SUTHERLAND SHIRE COUNCIL ASSESSMENT REPORT

Panel Reference	PPSSSH-134
DA Number	DA23/0196
LGA	Sutherland Shire
Proposed Development:	Demolition of existing structures and construction of a medical and child care centre
Street Address:	31 Koonya Circuit (Lot 23 DP 800924) 39 Willarong Road Caringbah (Lot 22 DP 800924) 41-49 Willarong Road (Lot 101 DP 417983) 29 Koonya Circuit (Lot 21 DP 800924)
Applicant/Owner:	Richard Seaward - Equity Trustees Limited as Custodian for HMC Funds Management Limited
Date of DA lodgement	20/04/2023
Number of Submissions:	6
Recommendation:	Refusal
Regional Development Criteria	Clause 5, Schedule 6 State Environmental Planning Policy (Planning Systems) 2021 - CIV > \$5M – Private infrastructure and community facilities
List of all relevant s4.15(1)(a) matters	<ul style="list-style-type: none"> • State Environmental Planning Policy (Planning Systems) 2021 • State Environmental Planning Policy (Resilience and Hazards) 2021 • State Environmental Planning Policy (Transport and Infrastructure) 2021 • State Environmental Planning Policy (Biodiversity and Conservation) 2021 • Sutherland Shire Local Environmental Plan 2015 (SSLEP 2015). • Sutherland Shire Devel

Figure 6: Landscaped Area Plan

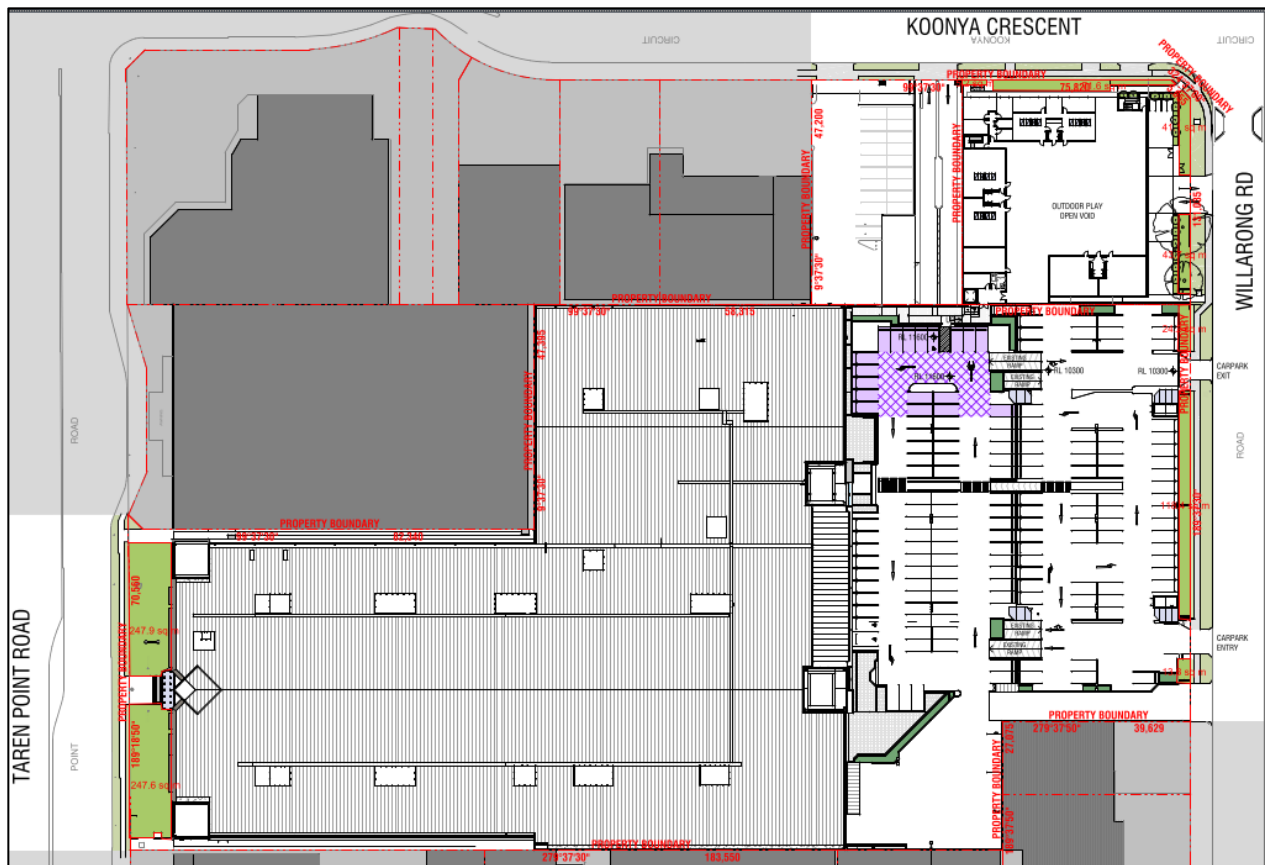
Whilst the applicant seeks to rely on retention of the landscape scheme approved under DA16/0223 as subsequently amended under MA18/0399, the landscape details for this are yet to be provided. This was a requirement of the Stage 2 works under the modified consent – works which have yet to be undertaken. Little weight is therefore given to reliance on this as an environmental planning ground. As discussed above and notwithstanding the quantum of landscaped area within the whole of site, and general landscape design being considered acceptable, the CI 4.6 justification is contingent on the successful retention of the 2 mature trees within the Willarong Road frontage of the site. The applicant's own Arborist Report states that the tree incursion is too great to enable their protection. Design of the proposed development therefore does not facilitate the retention of the trees. The proposal is therefore directly contrary to the statement made in the Clause 4.6, which states that the trees are to be retained.

There is an existing numeric deficiency across the whole of site and a separate development consent included a variation to the development standard. The proposed development seeks to erode this provision further than the existing development consent however the general approach to site planning with building / landscaped setbacks to the frontages of Koonya Circuit and Willarong Road is considered to be acceptable (excluding the tree concerns identified below). The quantum of landscaped area when isolated to the developable site area (i.e. the 2 lots) is generally commensurable to the size of the site. The selection of species is generally appropriate and the broader whole of site landscape strategy can be achieved and reinforced with suitable conditions of development consent in the event of an approval.
